EQUIPMENT UPDATE

Log Number: EU-07-389

Part Description: L-1X/L-1X16 CONTROL PANEL & WIRE HARNESS

Models Affected: L-1X & L-1X16

NEW DESIGNED LABEL

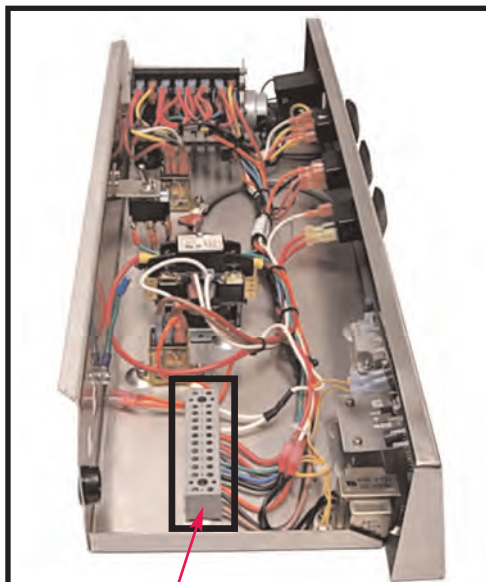
1. **Control Panel:** Newly designed label and slanted front panel to recess switches for additional protection.
2. **Control Switches:** Upgraded rocker style switches with power illumination built in.
3. **Temperature Controls:** Upgraded to digital display.
4. **Wire Harness:** "Molded Plug" removed and replaced with upgraded multi-wire power block.

NEW DIGITAL DISPLAY

MULTI-WIRE POWER BLOCK

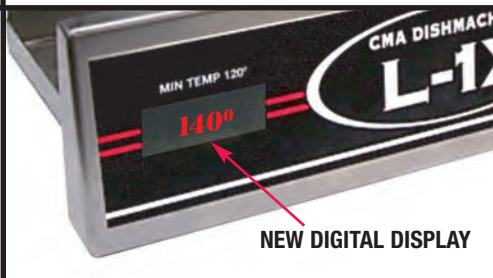
DISCONTINUED
MOLDED PLUG
